Strathfield Internal Development Assessment Panel Meeting

Friday, 14 February 2020

SUBJECT: DA2019/033/02 24 OXFORD ROAD, STRATHFIELD
LOT A IN DP 334827

Proposal: Section 4.55(2) modification application to delete the basement level and construct a garage, modify internal layout and amend window schedule.

Figure 3: Proposed modified ground floor plan

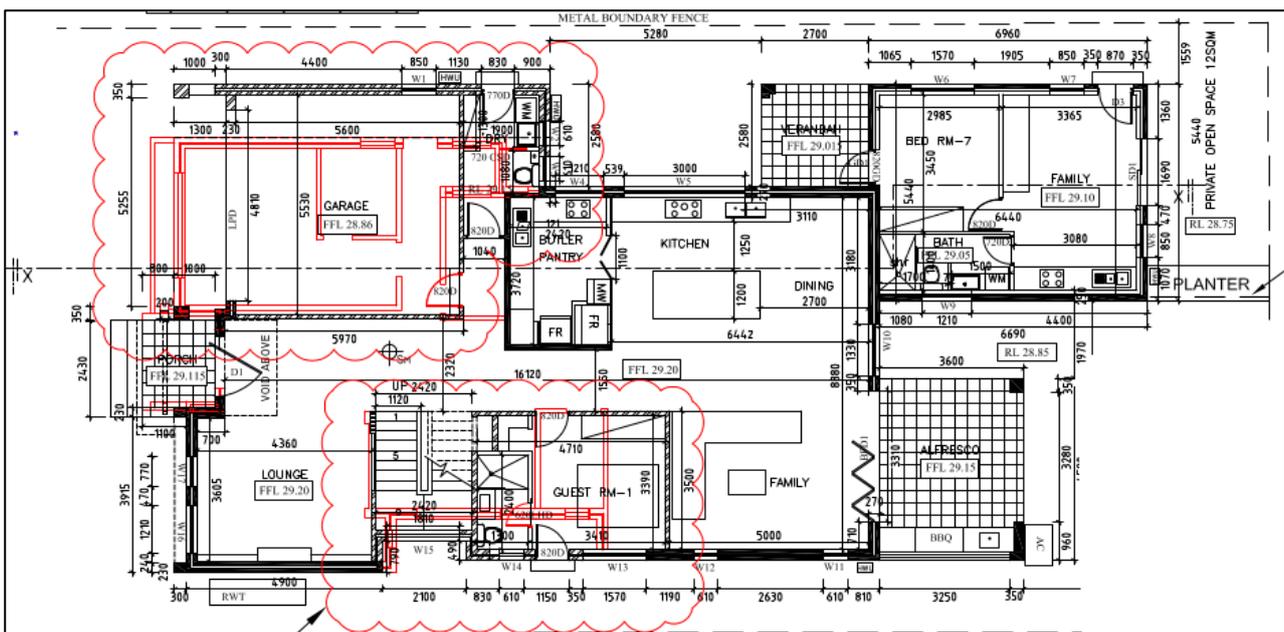
- Basement level deleted;
- Addition of a double garage and amended driveway;
- Re-location of the guest bedroom and adjoining ensuite;
- Minor modification to bedroom 2;
- Modification to western side setback of the stair case; and
- Location of laundry modified from western to eastern side of the dwelling.

Figure 4: Proposed modified first floor plan

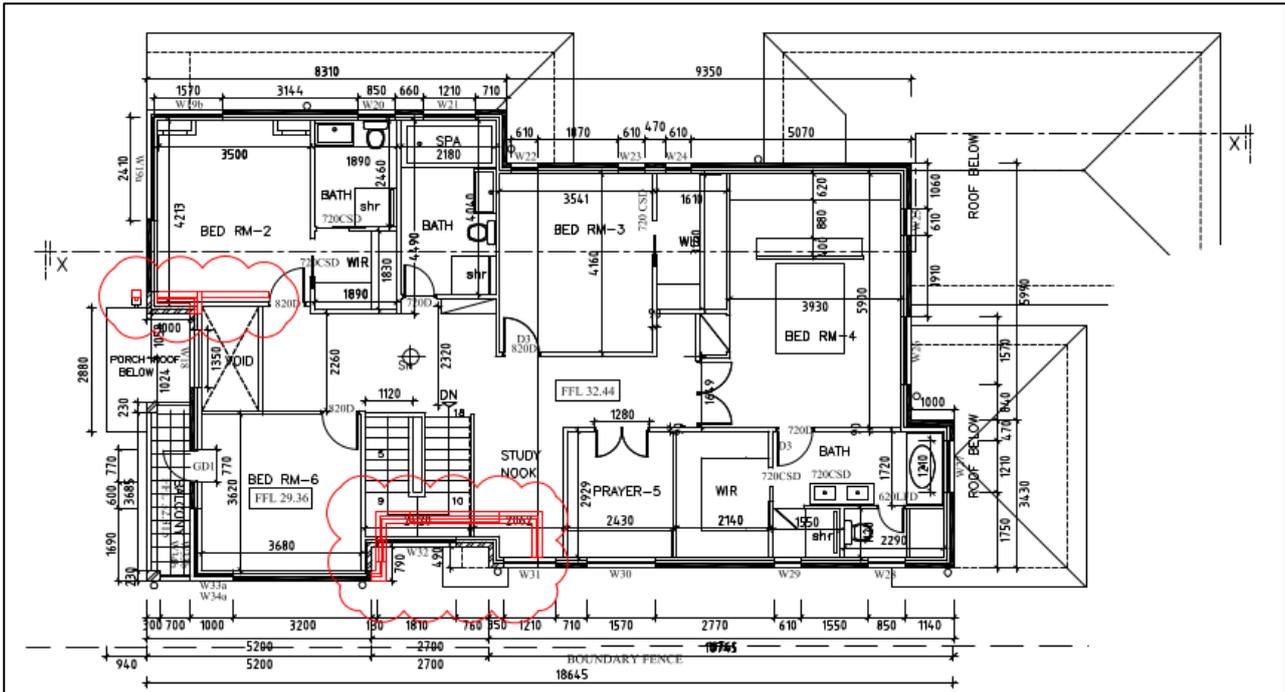
The application also seeks minor changes to the western side setbacks of the dwelling corresponding with the stair well and guest room on the ground floor and the stair well and study nook on the first floor. The increased side setbacks achieve compliance with the side setback controls and provide sufficient building articulation to the western side elevation.

- i) Windows W25 and W26 on the north-eastern elevation and W32 on the south-western elevation on the first floor depicted on Sheet No. A-05, First Floor Plan prepared by AMA Associates Sydney shall have a sill height of at least 1.7m above the finished floor level or have fixed, obscure glazing in any part of the windows less than 1.7m above the first floor finished floor level.

Figure 7: Proposed modified streetscape elevation.

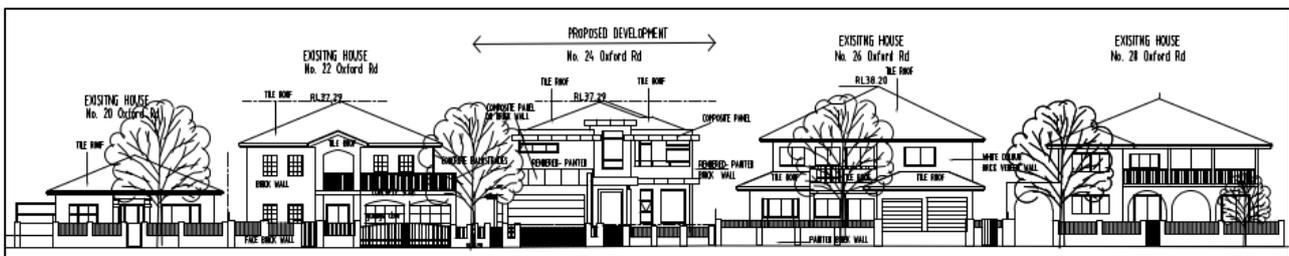
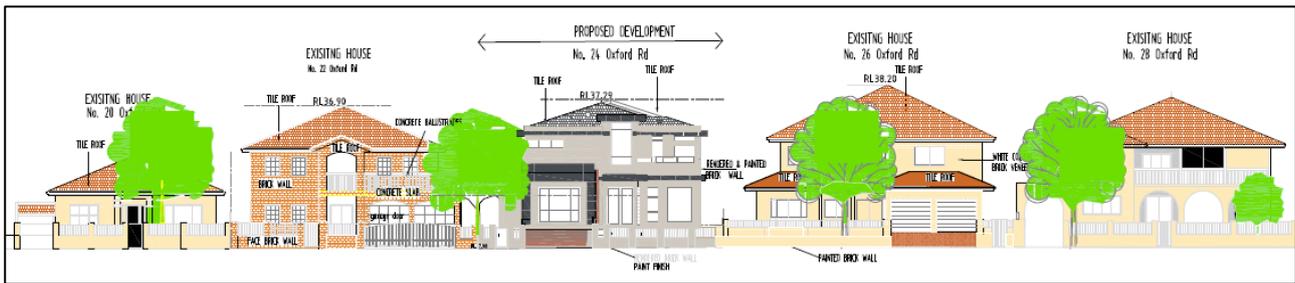
Comments: The modified design and appearance of the dwelling accords with the character of the streetscape. The proposed double garage is setback from the porch and the bedroom immediately above on the first floor so as not to dominate the front building façade. The proposal does not seek to alter the approved schedule of colours and external finishes. The proposed deletion of the basement is considered an improved outcome that is more consistent with the streetscape given that the immediate surrounding dwelling features at-grade parking.

Figure 7: Proposed driveway and garage.

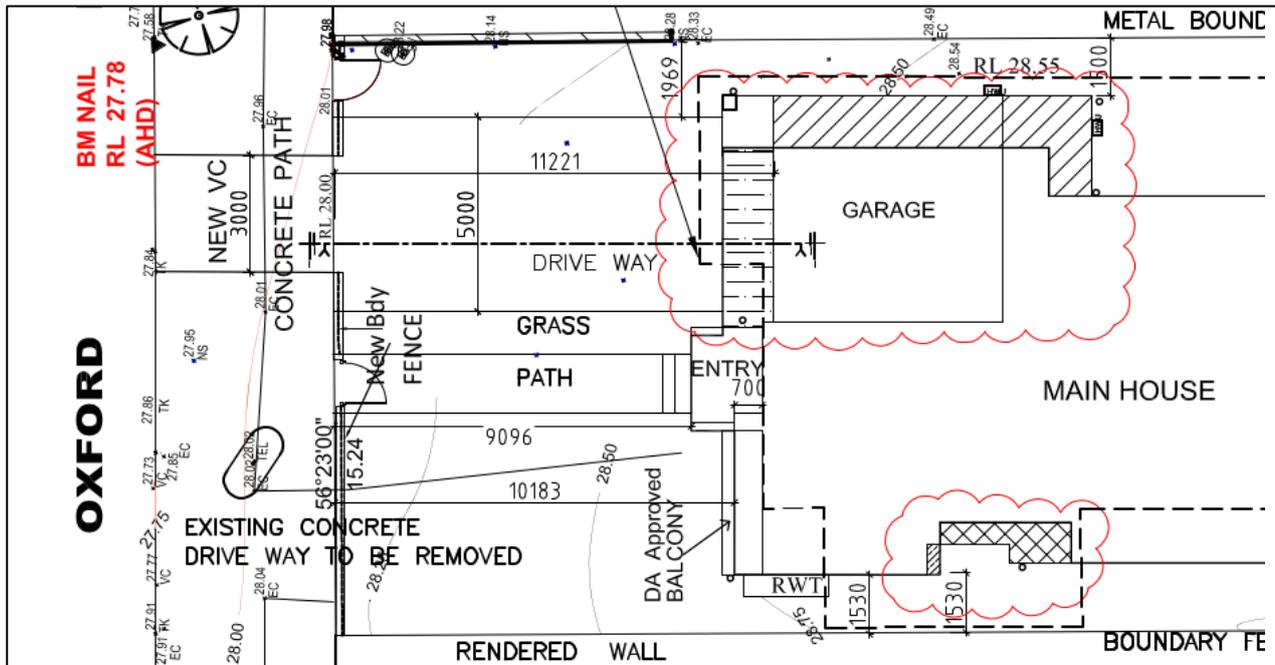
Comments: The modified proposal provides 36.75% (209.141m²) deep soil landscaping, contrary to the 38.5% (219.065m²) requirement and less than the 37.9% (215.65m²) under the parent

consent. The reduction in landscaped area is a result of the modified driveway design proposing a 5m wide driveway within the front setback. Condition No. 21 has been modified requiring the driveway at the front property boundary to be no more than 3m and tapered back to the double garage door. The driveway areas removed are to be replaced with deep soil landscaped areas (such as grassed turf or garden beds). The recommended condition will provide approximately an additional 9.5m² deep soil landscaping.
